CITY OF ALBUQUERQUE

**RE: Santa Barbara Arsenic Treatment Facility
3301 Claremont Ave NE
Grading and Drainage Plan
Engineer's Stamp Date: 08/12/2025
Hydrology File: H16D100
Case # HYDR-2025-00291**

Based upon the information provided in your submittal received 08/12/2025, the Grading & Drainage Plans are not approved for Building Permit. The following comments need to be addressed for approval of the above referenced project:

—		—		—		THIS BAR MEASURES 1" AT FULL SCALE (ANSI D)		MAPS/RECORDS INFO.						DRAWINGS CORRECTED BY COMPANY NAME DATE MMM. YYYY		08/12/2025		WATER AUTHORITY CONSTRUCTION PROJECT NO. 2308.010		ZONE MAP NO. H-16-Z		SHEET C-14A

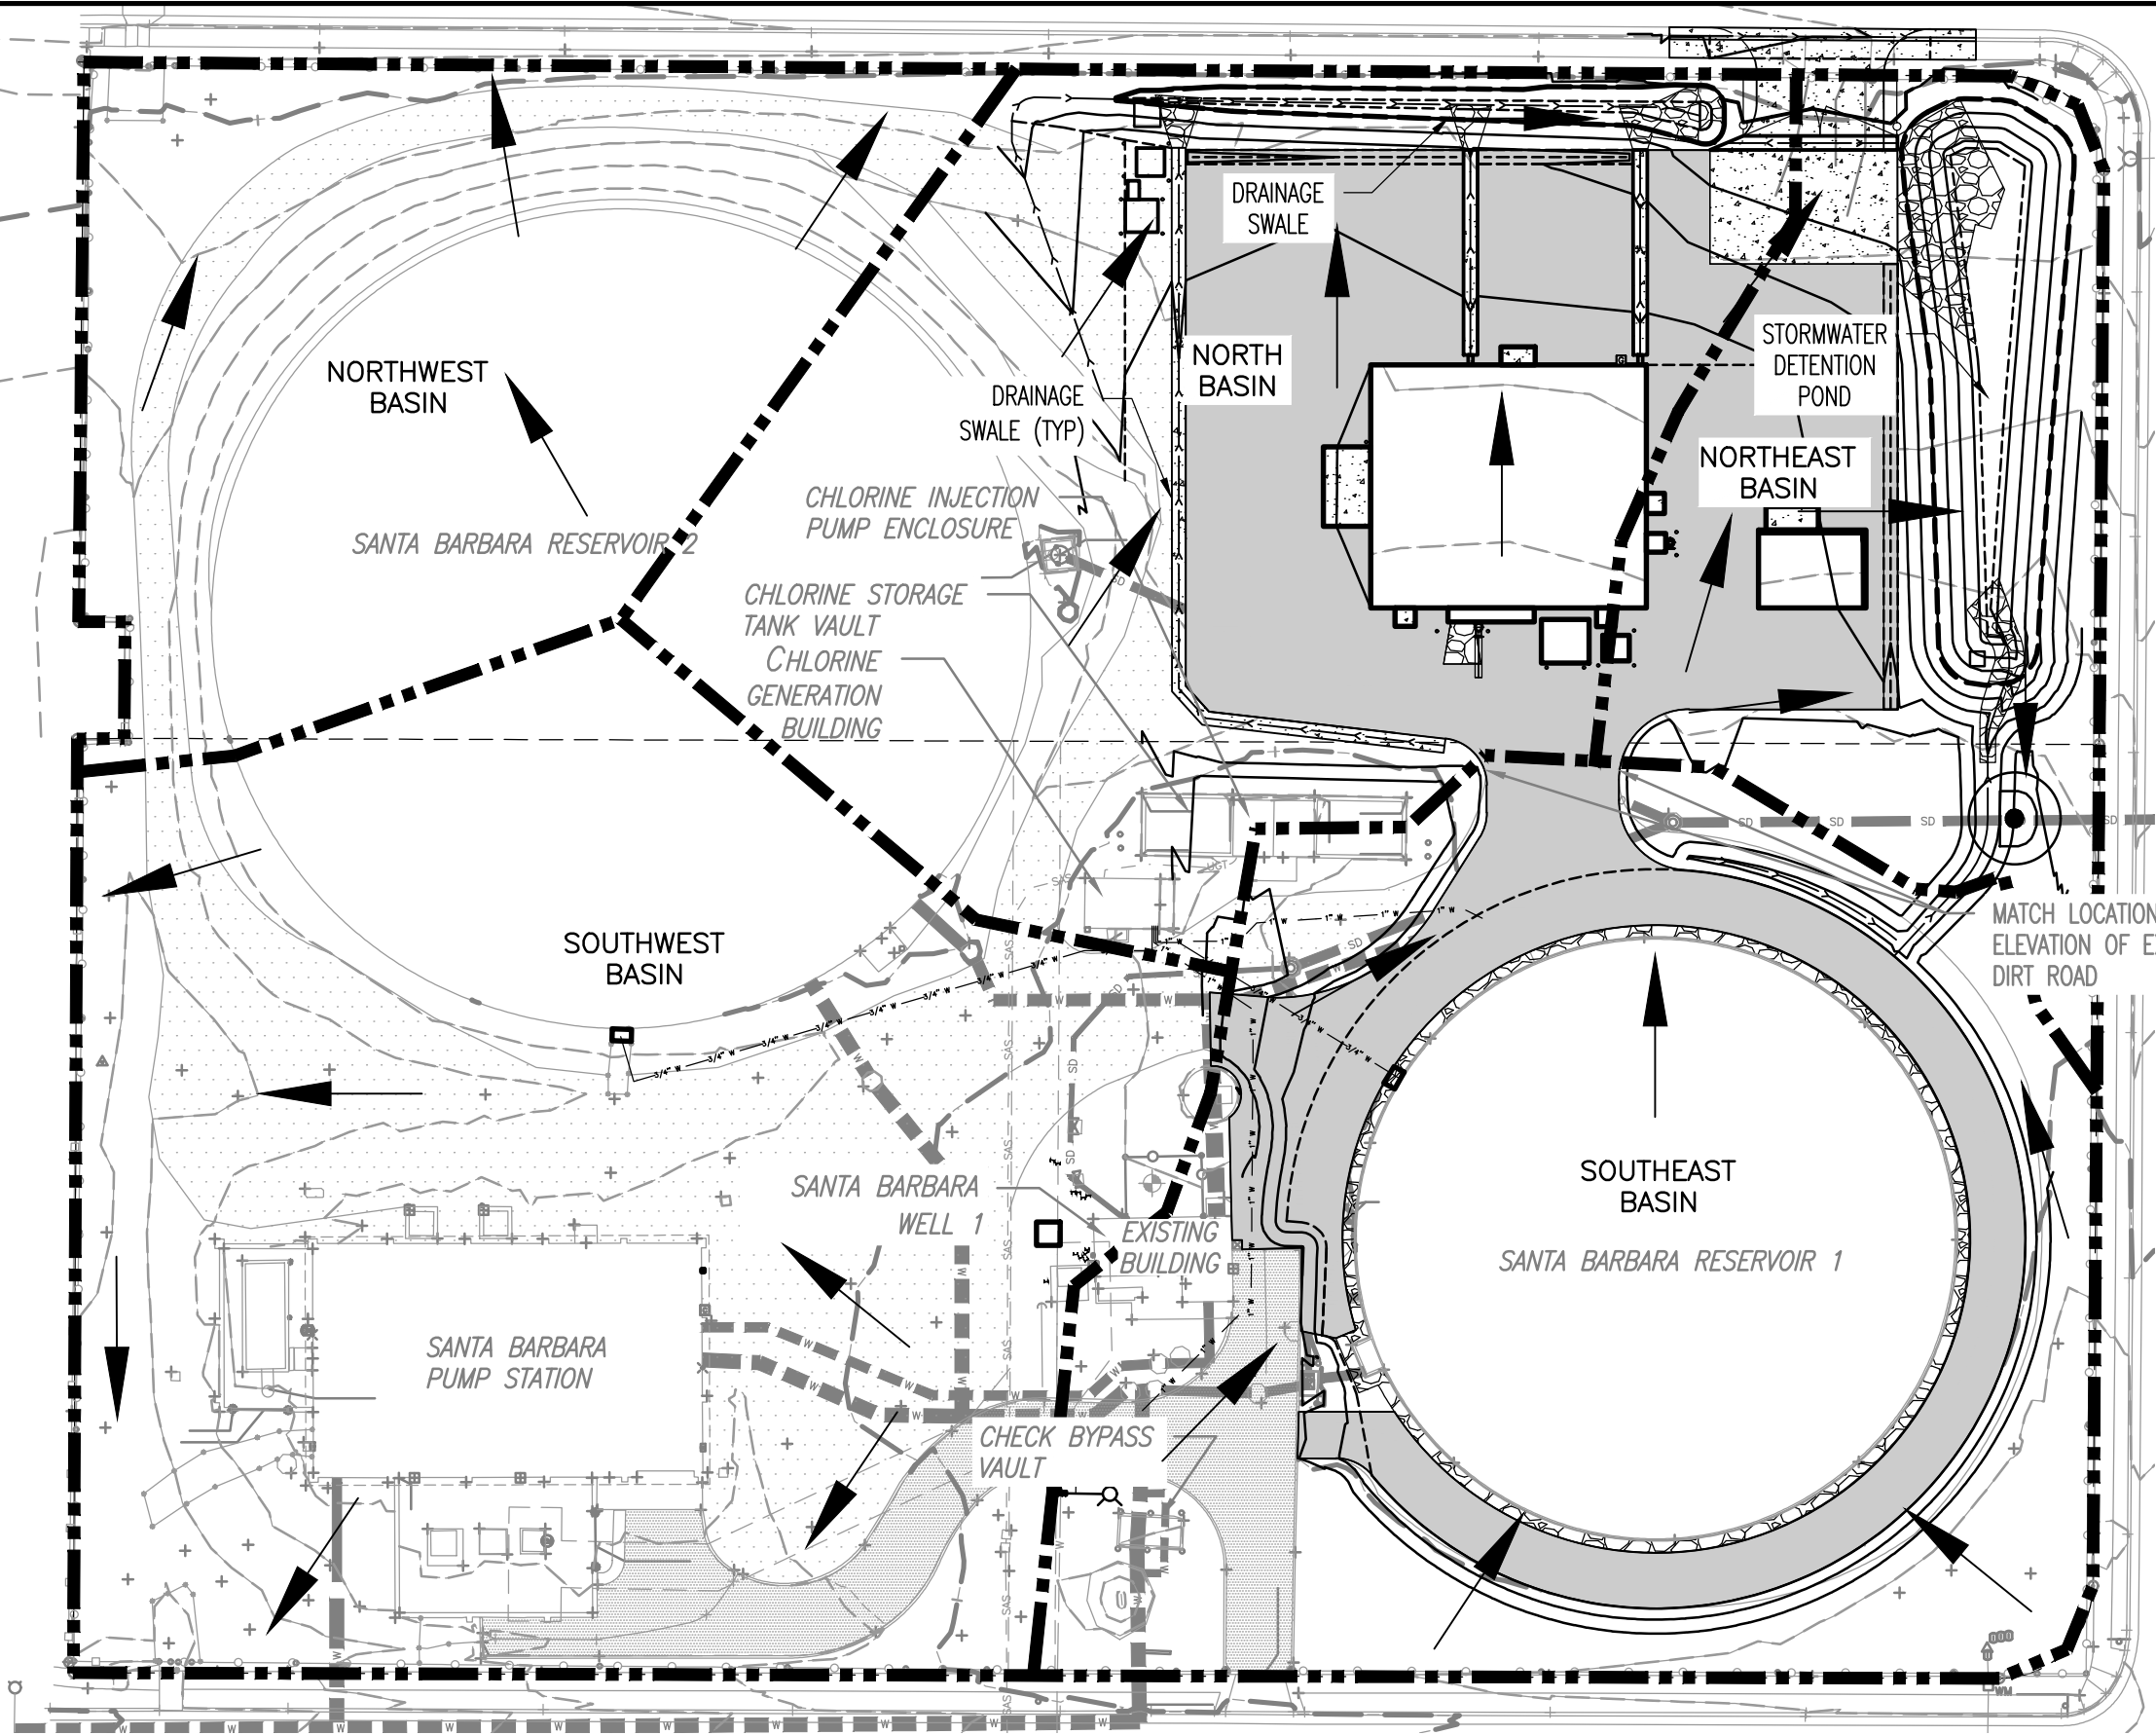
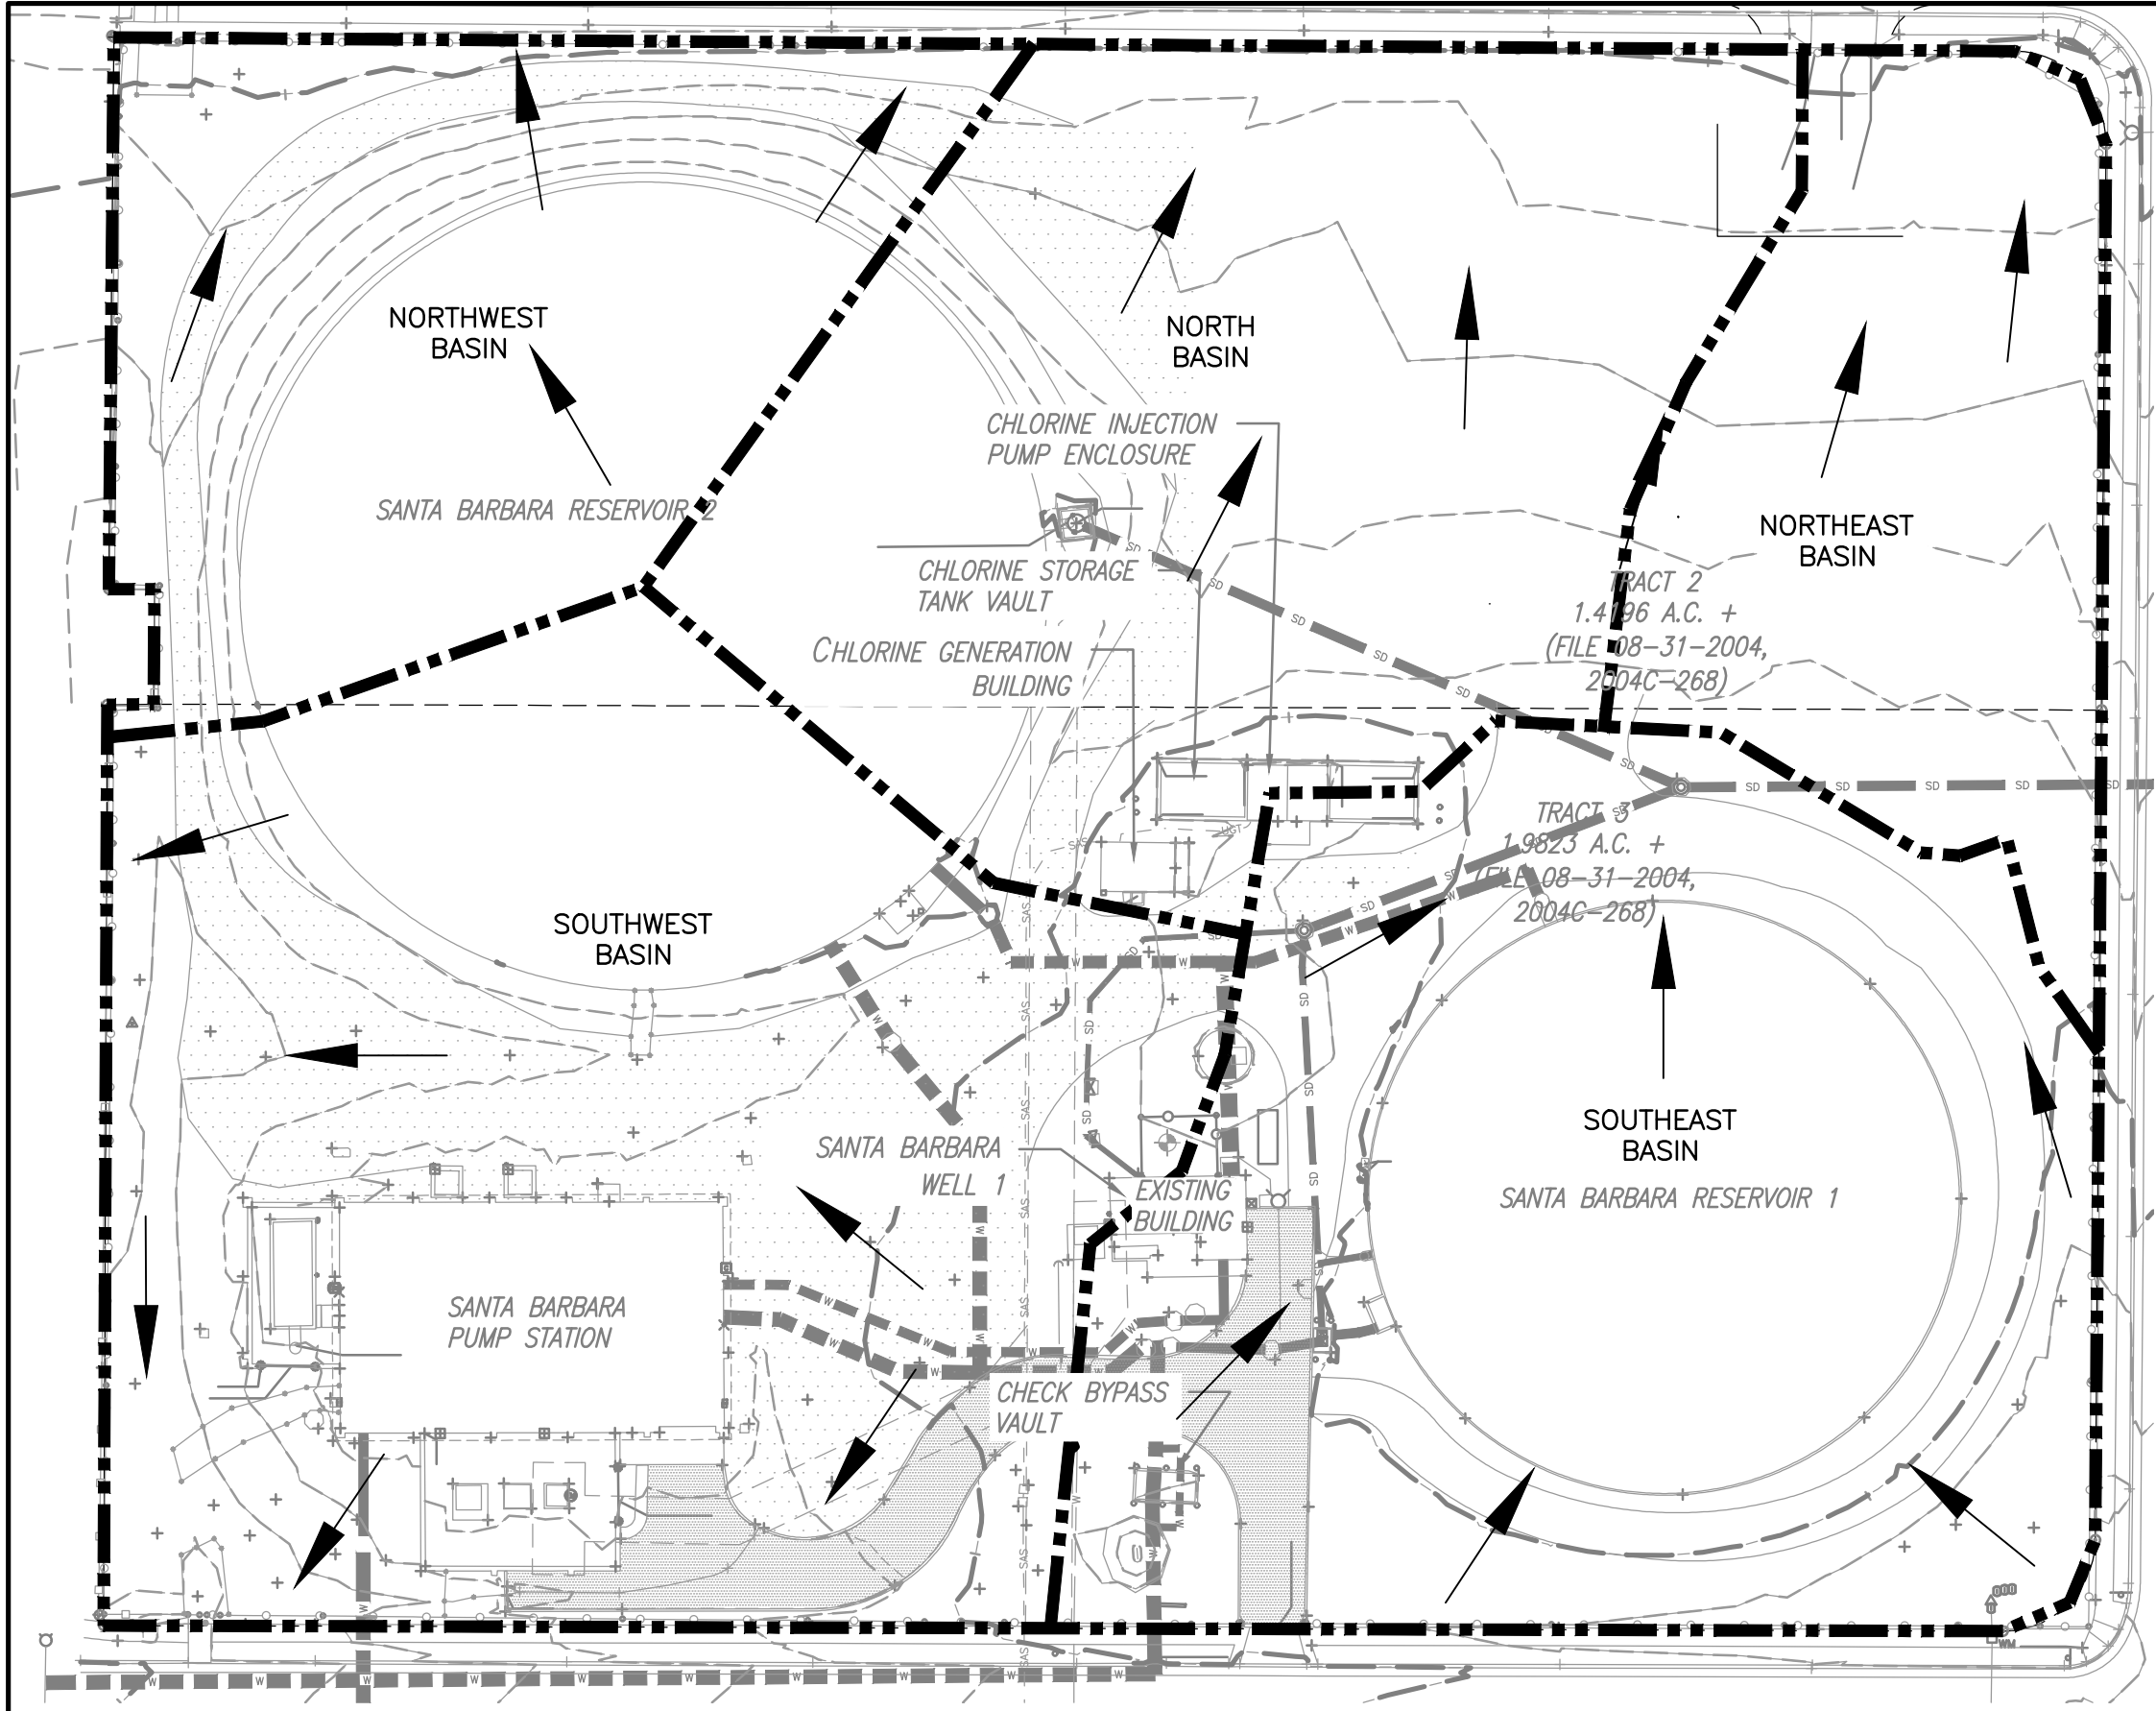
1. Please provide the FIRM Map and floodplain note with effective date.

BASED ON THE FEMA NATIONAL FLOOD HAZARD LAYER FIRMETTE, THE SITE IS NOT LOCATED WITHIN A SPECIAL FLOOD HAZARD AREA. THE NEAREST MAPPED FLOOD ZONES (ZONES A AND AO) ARE MORE THAN 0.20 MILES AWAY AND DO NOT IMPACT THE SITE.
